# TOWN OF NORTH CASTLE

## RPRC RETURN LETTER

Application Number: 2023-0863

Street Location: 99 BYRAM RIDGE RD

### Driveway Profile

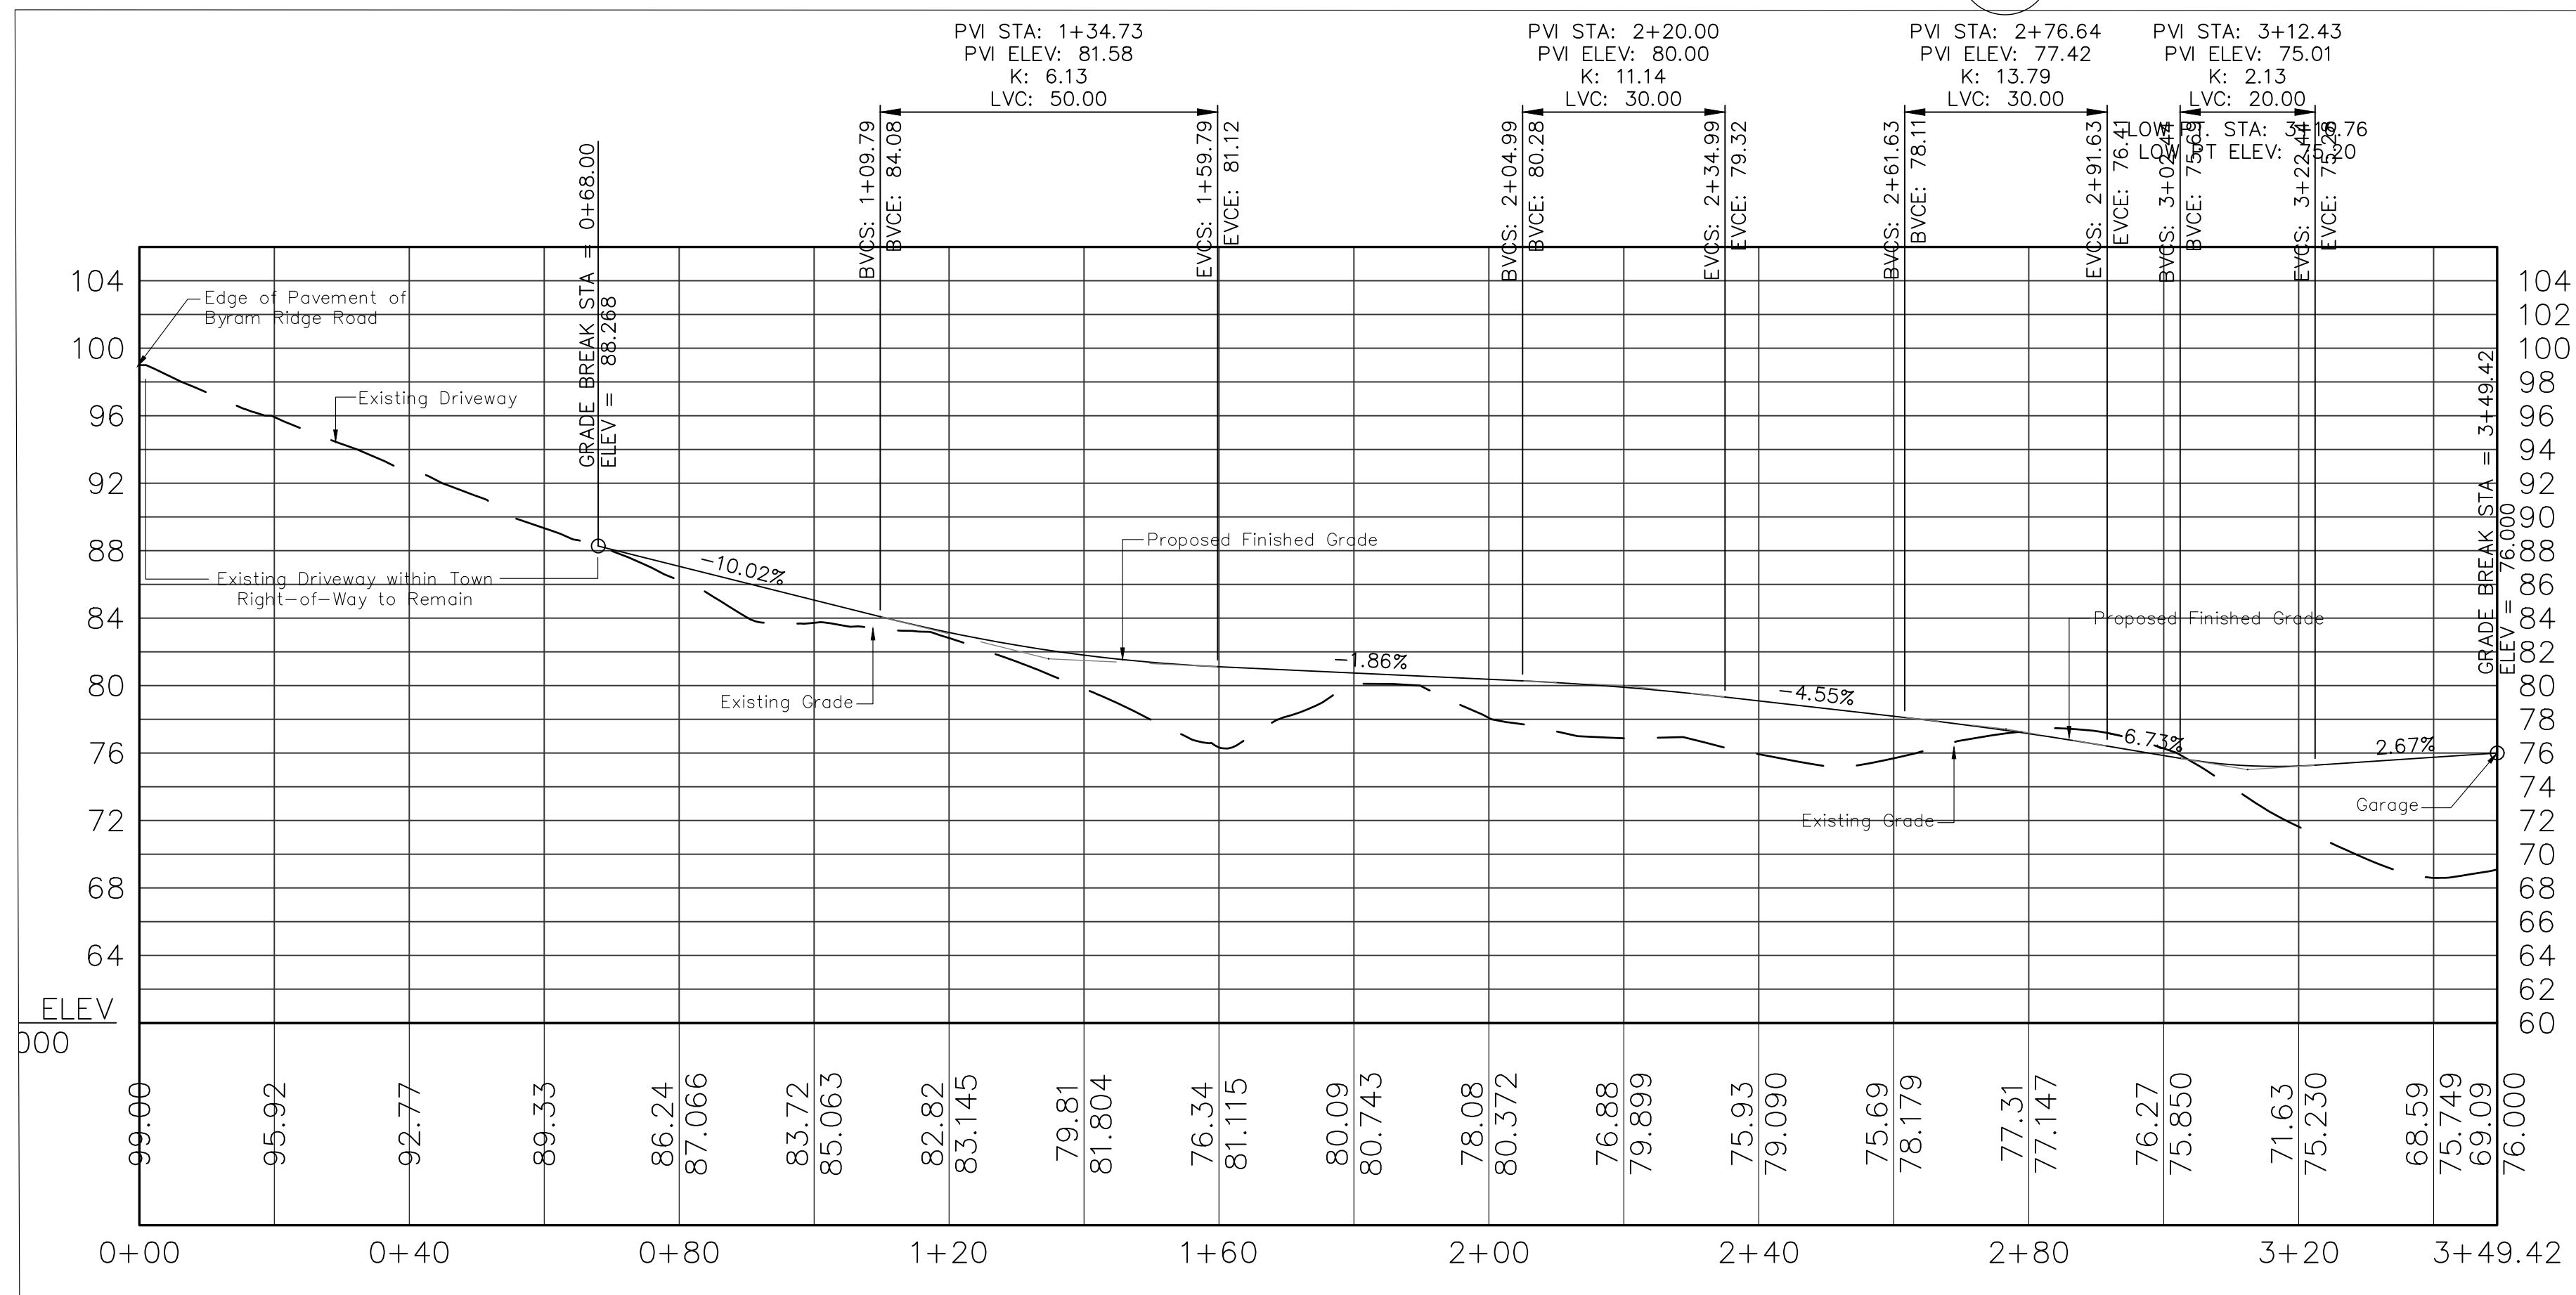
*• The plan shall include a driveway profile for the full extent of the drive demonstrating compliance with Section 355-59, Driveways, of the Town Code. The profile shall include dimensions, grades and vertical curve data, as needed, to demonstrate compliance with specific provisions related to maximum allowable grades for the platform area and drive. The profile should illustrate the location of the edge of the existing roadway and property line. It is noted that the plan proposes to maintain the upper portion of the drive and connection to the road. However, the existing drive was demolished or is otherwise in need of reconstruction as a result of the prior application.*

Response: Please refer to the driveway profile on drawing C-112. As can be seen in the profile, the maximum centerline of driveway slope is proposed to be 10.02%, with the driveway slope being 1.86% along the front of the house, and 4.55% and 6.73% in driving down to the garage apron.

### Erosion Control Mat on Slopes

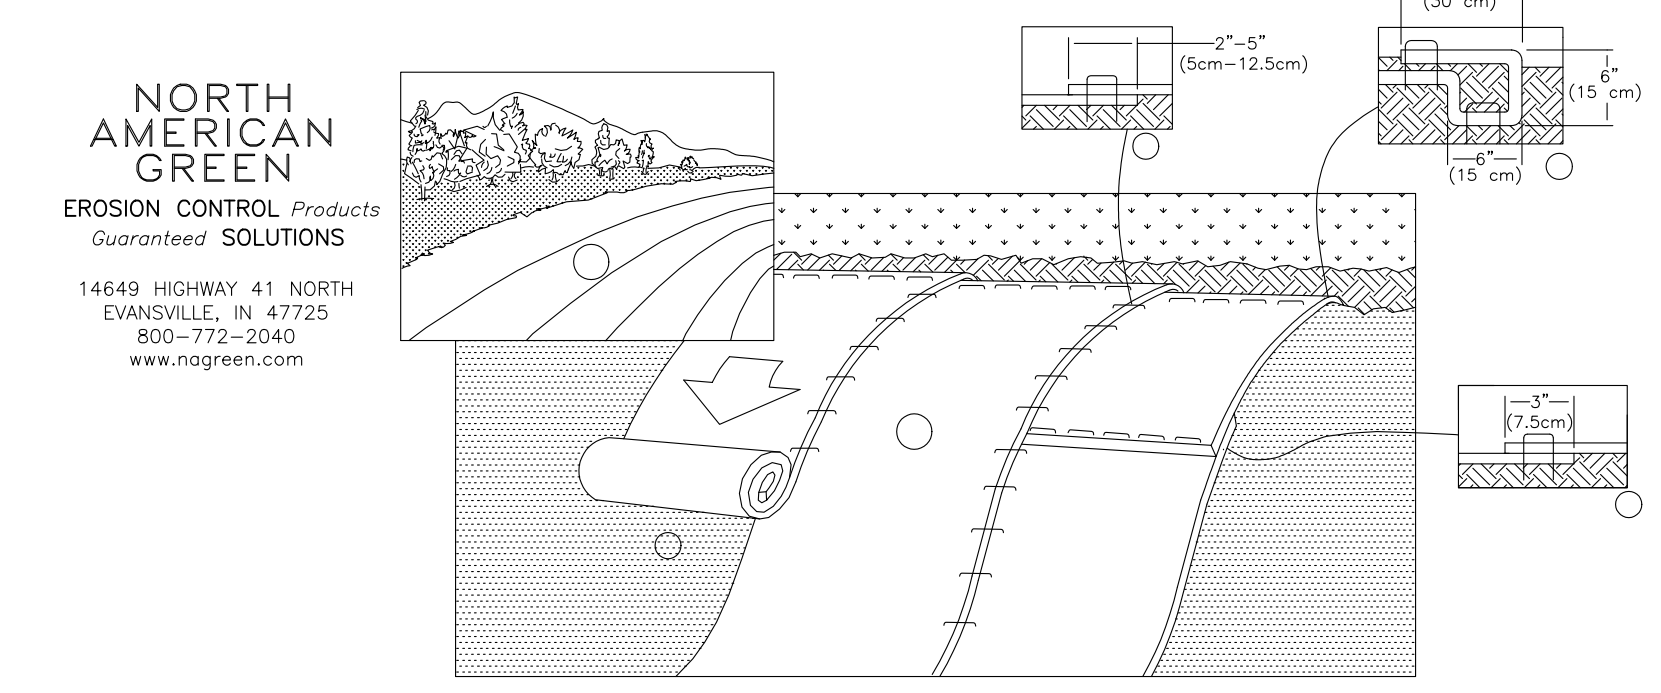
- *The Erosion and Sediment Control Plan should include a suggested construction sequence, as well as identify areas of steep slopes to be stabilized with erosion control blankets or other appropriate means. Provide details. The plan shall also include a temporary sediment trap appropriately sized to collect sediment laden runoff during construction prior to discharging from the site.*

Response: The Construction Sequence Narrative may be referenced on drawing C-103. The location of an erosion control mat is shown on that drawing with the detail provided on drawing C-112.

Proposed Black Aluminum Pool Fence and Gate

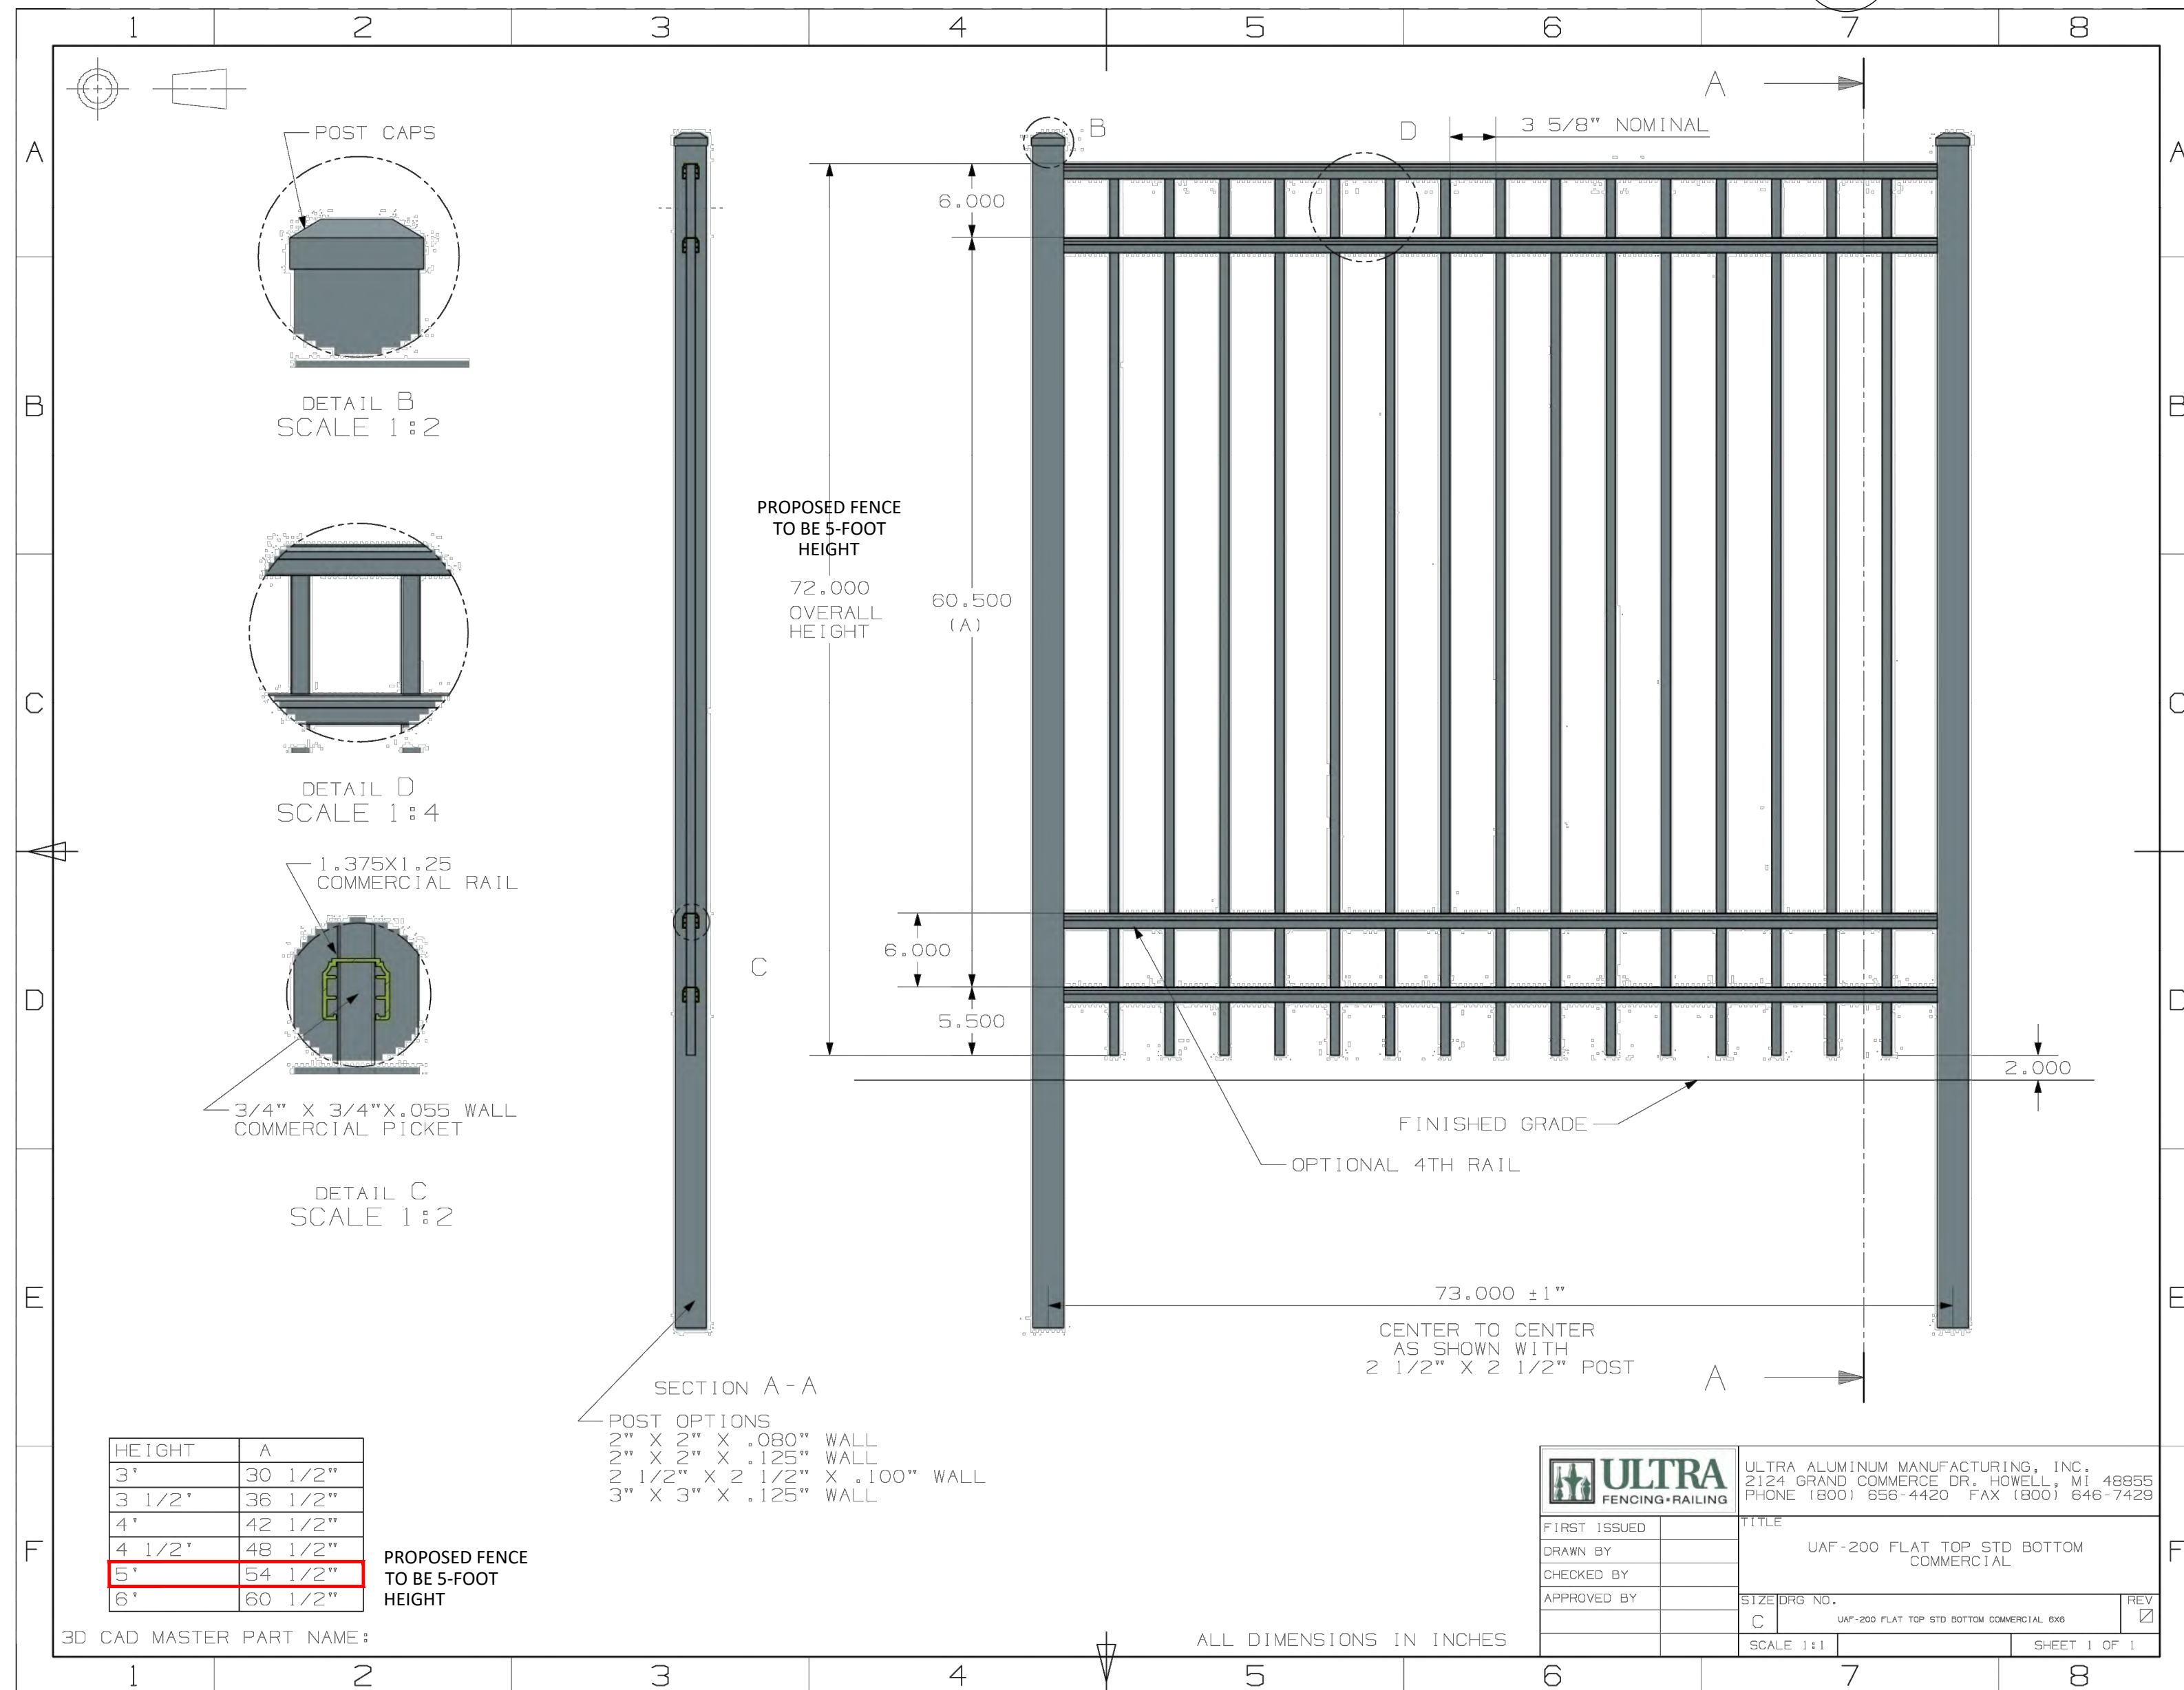
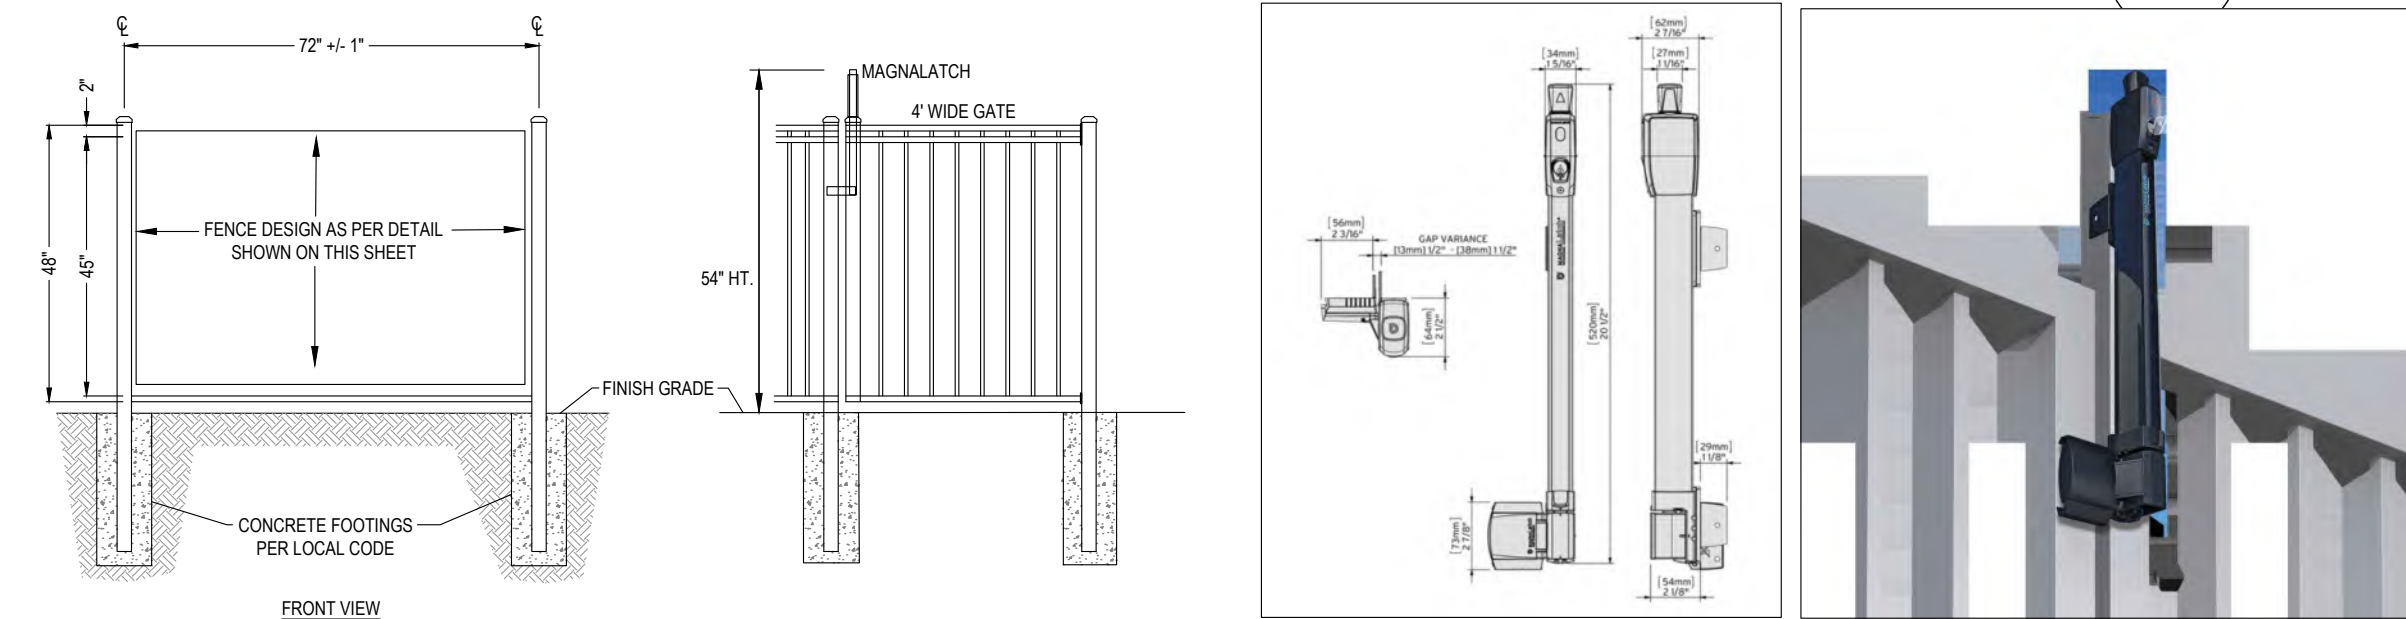
- *The plan shall include a pool fence and gate detail. The plan shall delineate the limits of each fence type and locate all gates. The plan shall note that the pool fence and gate shall comply with all applicable NYS Building Code requirements.*

Response: The amended plans (see drawing C-101 and C-102) show the location of the proposed pool fence and gates. The pool fence is to extend from the house to the northern property line. The pool fence will also be constructed from a retaining wall to the southern property line. A chain link fence will be constructed along the property line in the side and rear yard as shown. A detail of the proposed pool fence and gate and notes regarding the installation of the fence are on drawing C-113.
